BLOCK 136

LAND USE HEARING #2

JANUARY 22, 2015

East Facade Balcony Scheme - Revised

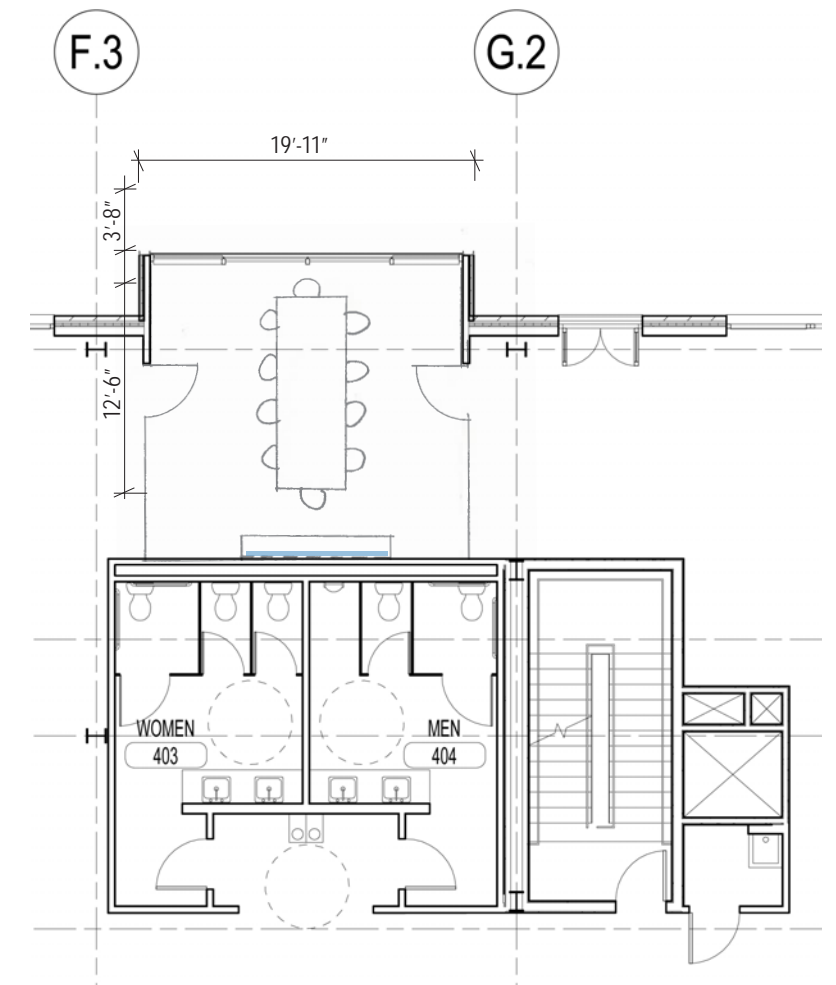
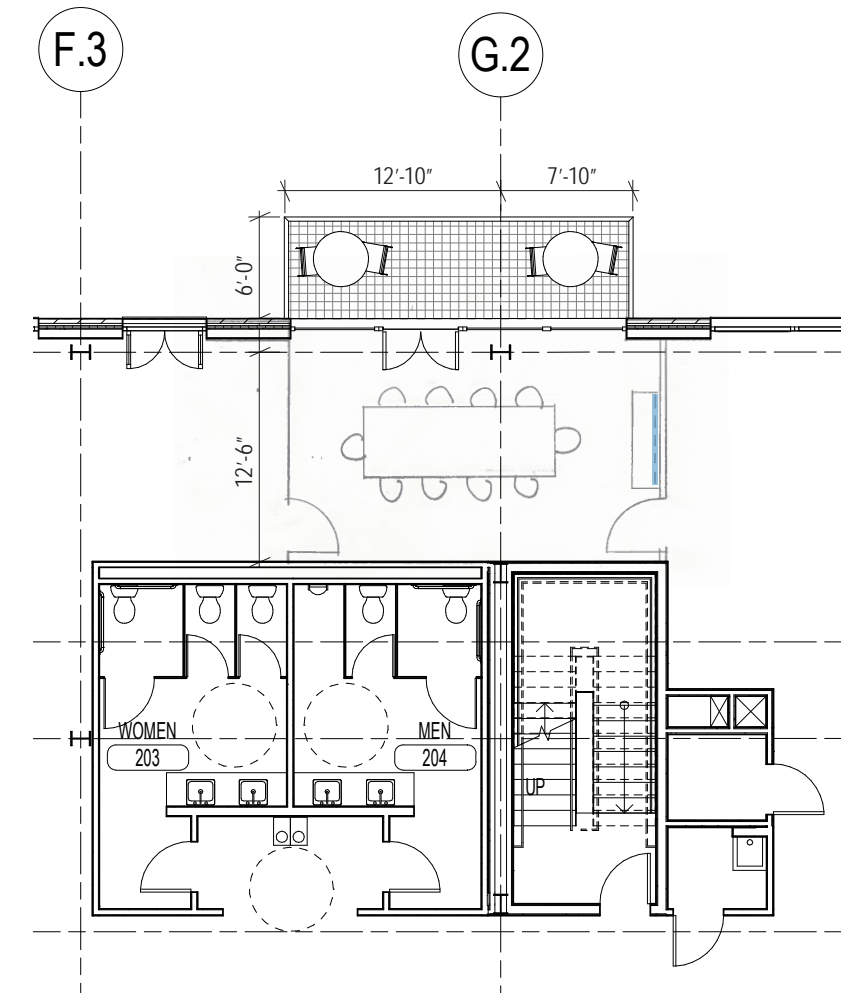
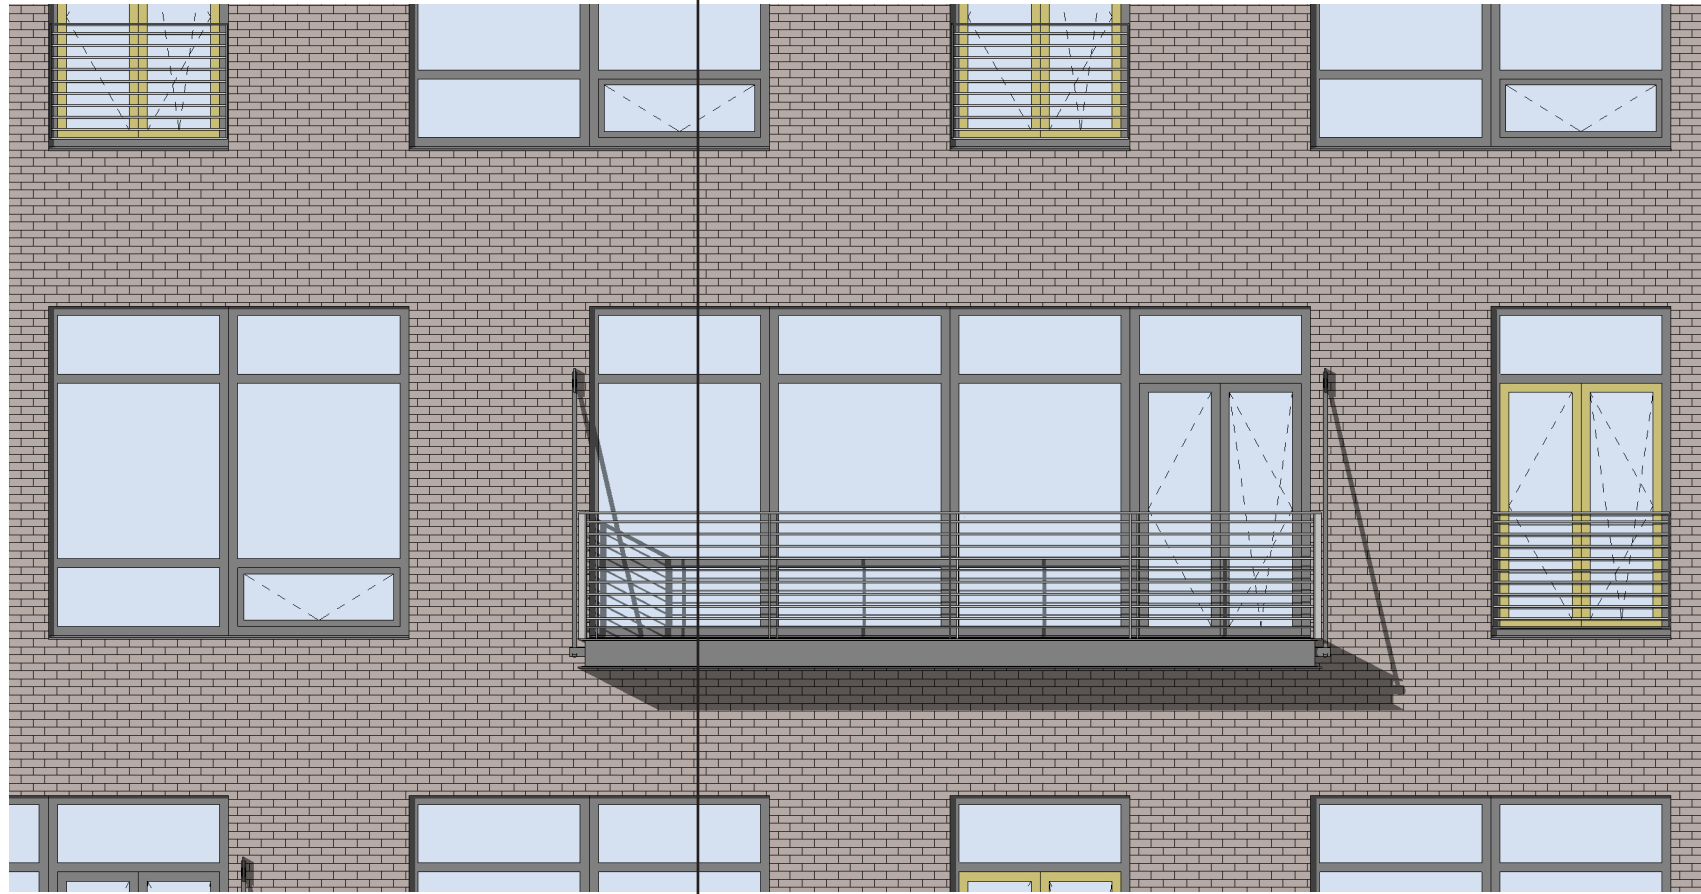
- Revise canopies to have continuous weather protection
- Study the removal of the bays on the east facade
- Study the detailing and play of light on the brick

- 130 sf deck X (4) = 520 sf
